ORDINANCE NO. 608H

**AN ORDINANCE APPROVING
A PRELIMINARY PLAT TITLED
CROSSLINK BUSINESS PARK NO. 2 SUBDIVISION**

Re: 2023-02; Crosslink Business Park 2 Subdivision
Proposed Cold Storage Facility
City of Belvidere
Plat of Subdivision and Engineering Plan Review

PRELIMINARY PLAT OF CROSSLINK BUSINESS PARK NO. 2 SUBDIVISION

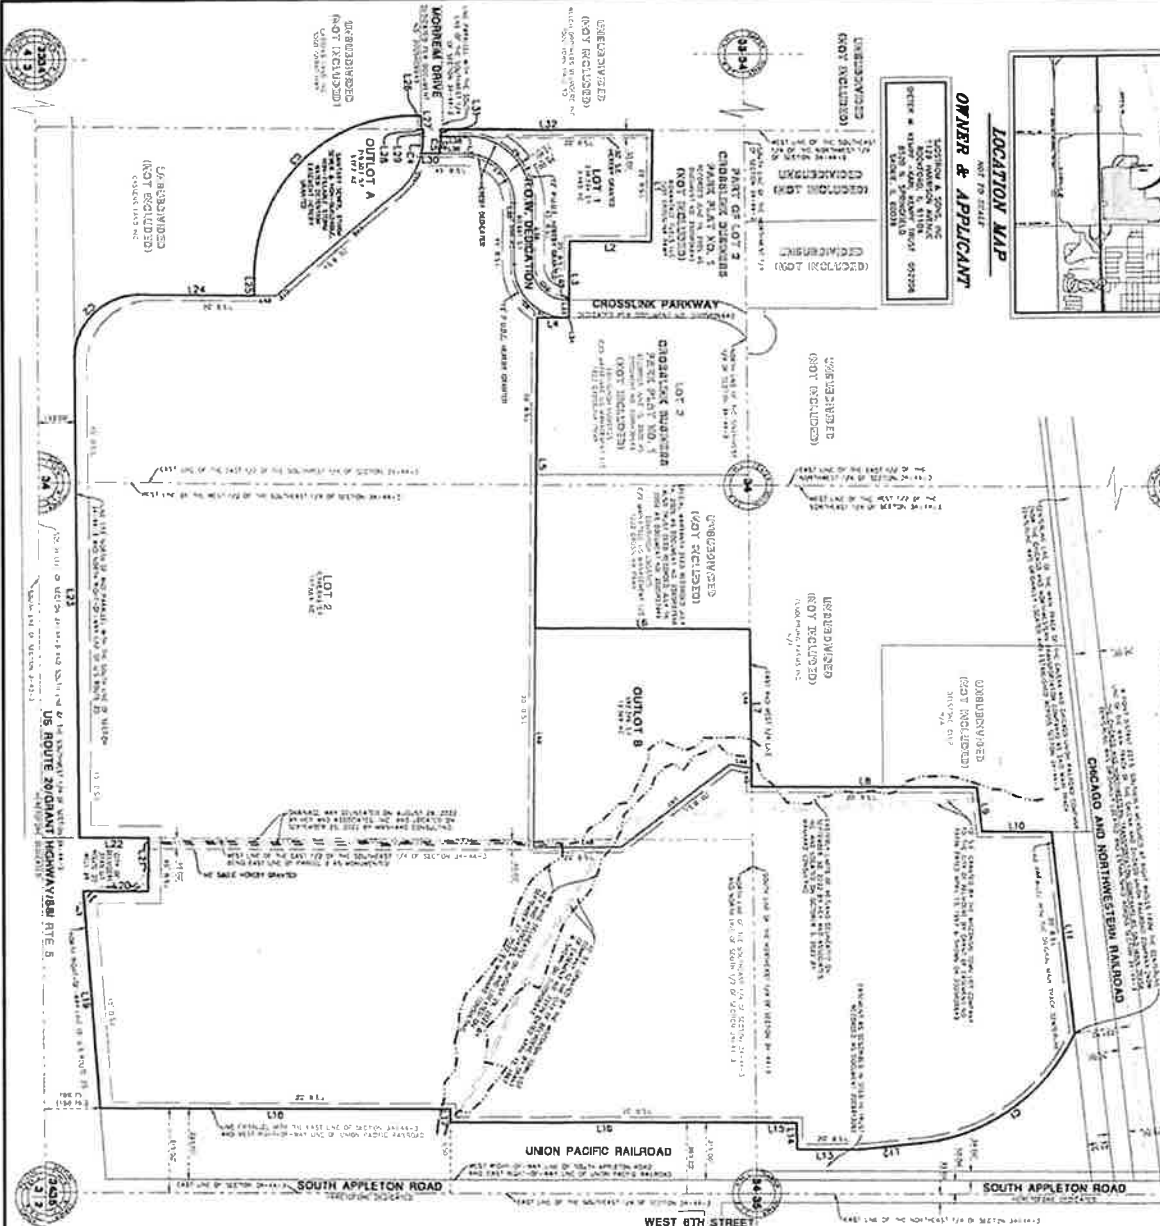
24. Missing Owners Endorsement signature block.
25. No existing monuments shown or called out on existing boundary (sheet 2 of 2) at boundary corners or section corners.
26. Provide Plat of Vacation for Crosslink Parkway and Morreim Drive for review
27. No topographic survey and drainage profile shown per 765 ILCS 205/1.
28. No easements shown for proposed detention ponds shown on engineering plans.
